UNITED STATES PATENT AND TRADEMARK OFFICE

APPLICATION NO.	FILING DATE	FIRST NAMED INVENTOR	ATTORNEY DOCKET NO.	CONFIRMATION NO.
09/974,780	10/09/2001	Max Schaldach	7040-46	6883

**Office Action Summary**

FIG. 1

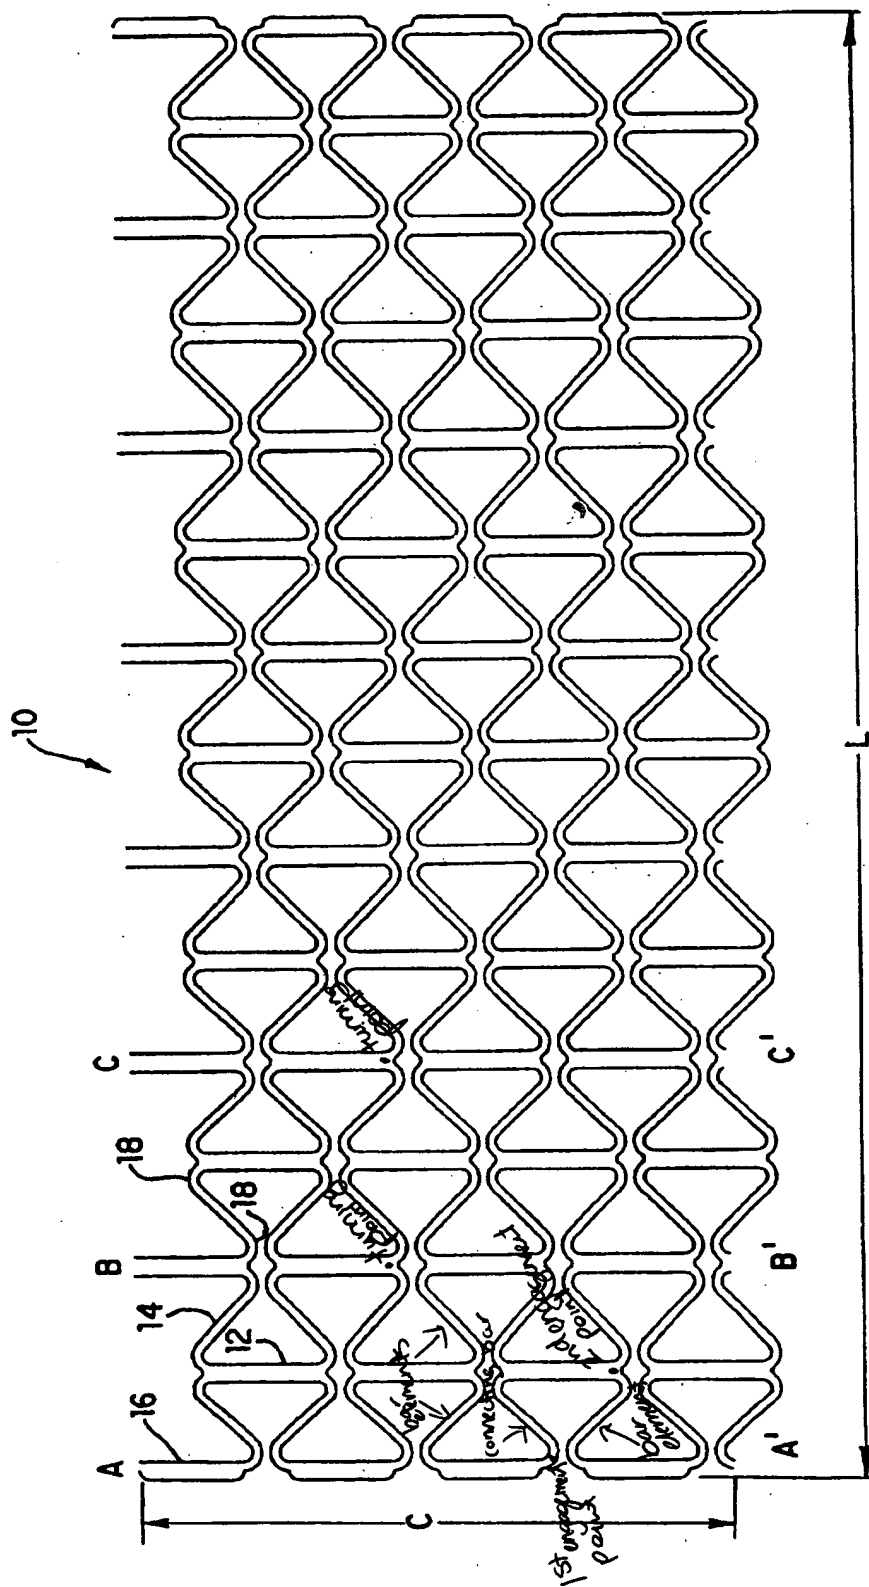
Regarding claims 1 and 60, Fischell discloses a stent comprising: a tubular body, a peripheral surface of which is formed by a plurality of support portions that extend in a longitudinal direction of the stent, the support portions comprising: a plurality of bar elements; and a plurality of connecting bars that connect the bar elements; wherein the support portions form a plurality of support portion groups with at least a first support portion and a second support portion in adjacent relationship thereto in a peripheral direction of the stent, the bar elements of which extend in a meander configuration in the longitudinal direction of the stent, and wherein a first engagement point of the connecting bars engages the first support portion and a second engagement point of the connecting bars engages the second support portion, such that the first and second engagement points are spaced apart from each other in the longitudinal direction of the stent and the connecting bars are configured and arranged so the spacing in the longitudinal direction between the first and

second engagement points changes upon expansion of the stent to compensate for a reduction in length of the respective support portions (see attached FIGS 1 and 3).

Regarding claim 2, Fischell discloses that at least the bar elements of a first support portion and of the two second support portions arranged in the peripheral direction of the stent at both sides of the first support portion extend in a meander configuration in the longitudinal direction of the stent and the first engagement points of the connecting bars engage the first support portion and the second engagement points of the connecting bars engage one of the two second support portions, wherein the first and second engagement points are spaced relative to each other in the longitudinal direction of the stent and the connecting bars are configured and arranged so that the spacing in the longitudinal direction of the stent changes between the first and second engagement points changes upon expansion of the stent in the same manner (see attached FIGS. 1 and 3).

Regarding claims 34-40, Fischell discloses that the bar elements of the first and second support portions are of substantially the same periodic configuration and a length of the connecting bars is such that the adjacent bar elements in the first condition of the stent are displaced relative to each by up to a quarter period in the longitudinal direction of the stent (see attached FIG. 1).

Regarding claims 41-49, Fischell discloses that the bar elements of the first and second support portions are of substantially the same period configuration and a length of the connecting bars is such that in the second condition of the stent the adjacent bar elements extend substantially in phase with each other with respect to the longitudinal direction of the stent (see attached FIG. 2).

FIG. 3

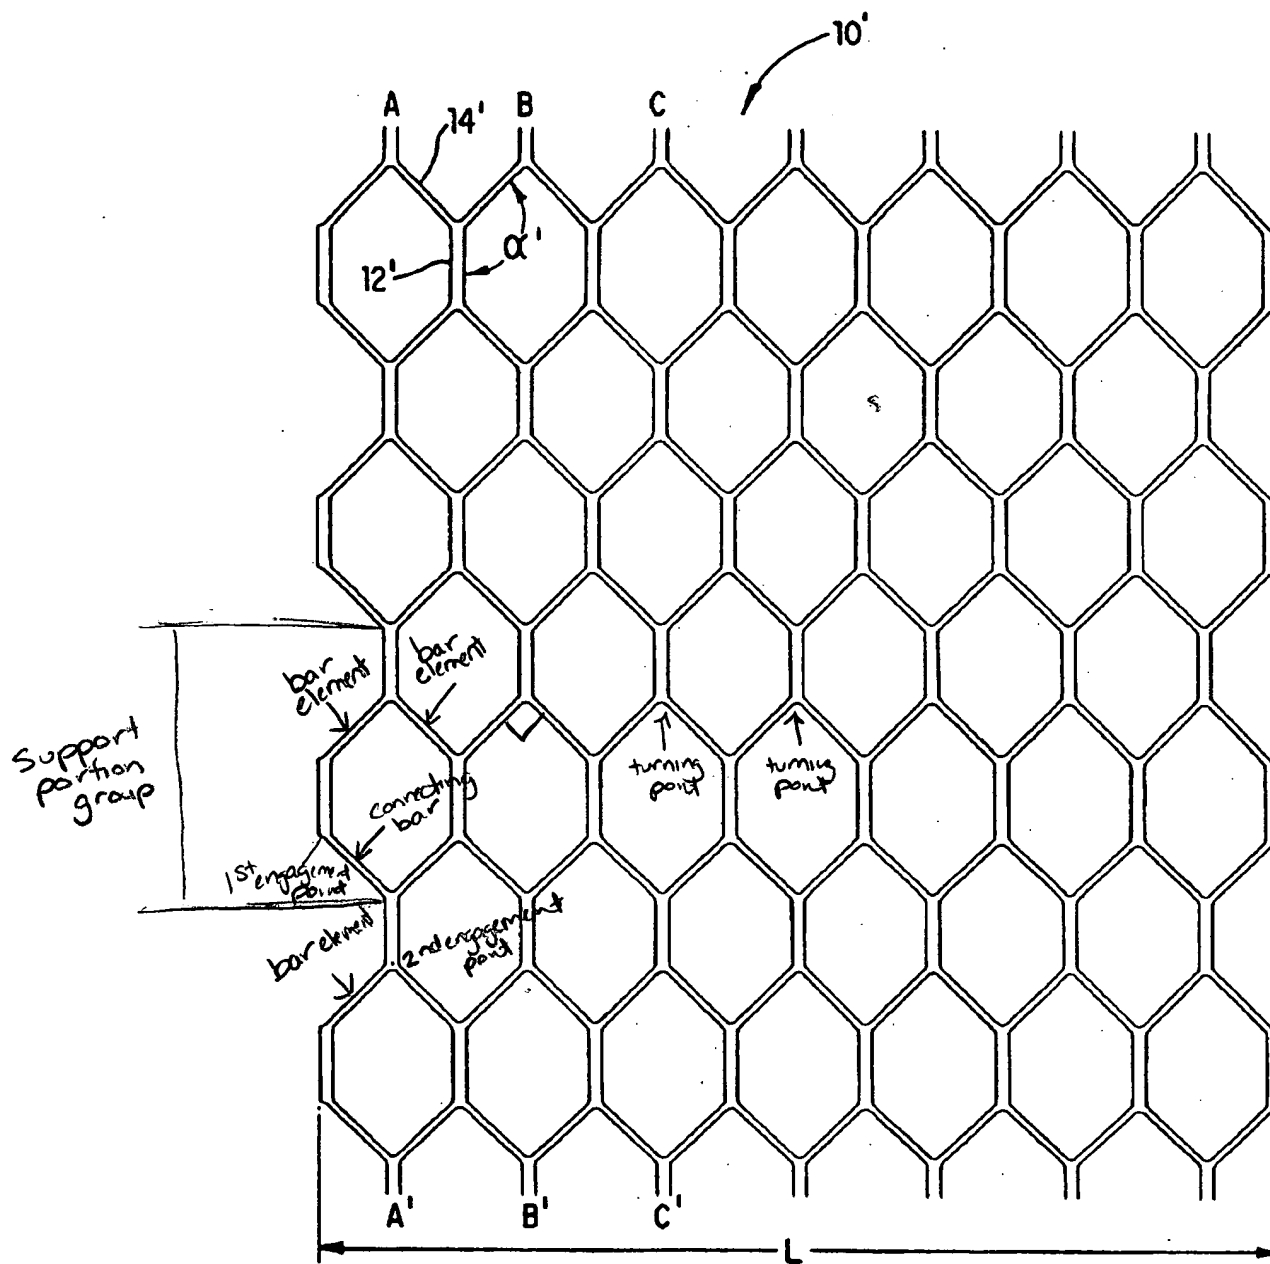
Regarding claims 3 and 5, Fischell discloses that at least the first engagement points of the connecting bars are located near a turning point of the bar element to which the connecting point is engaged (see attached FIG. 3).

Regarding claim 4 and 6, Fischell discloses that the second engagement points of the connecting bars are located near a turning point of the bar element to which the connecting point is engaged (see attached FIG. 3).

Regarding claim 7-10, Fischell discloses that the connecting bars are of a *substantially* straight configuration (see attached FIG. 3).

Regarding claims 11-15, Fischell discloses that a connecting line between the first and second engagement points extends substantially in the longitudinal direction of the stent (see attached FIG. 3).

Regarding claims 16-21, Fischell discloses that at least one support portion is formed by bar elements extending in a meander configuration in the longitudinal direction of the stent, wherein the bar elements comprise two bar element portions that are adjacent in the longitudinal direction of the stent and which extend between a turning point to form the limbs of a V-shape (see attached FIG. 3).

Regarding claims 22-33, Fischell discloses that the bar element portions include an angle of 90 degrees (see FIG. 3).

Regarding claim 59, Fischell discloses that at least one support portion formed by a bar element, the direction of curvature of which changes in a central region between a pair of turning points (see attached FIG. 3).
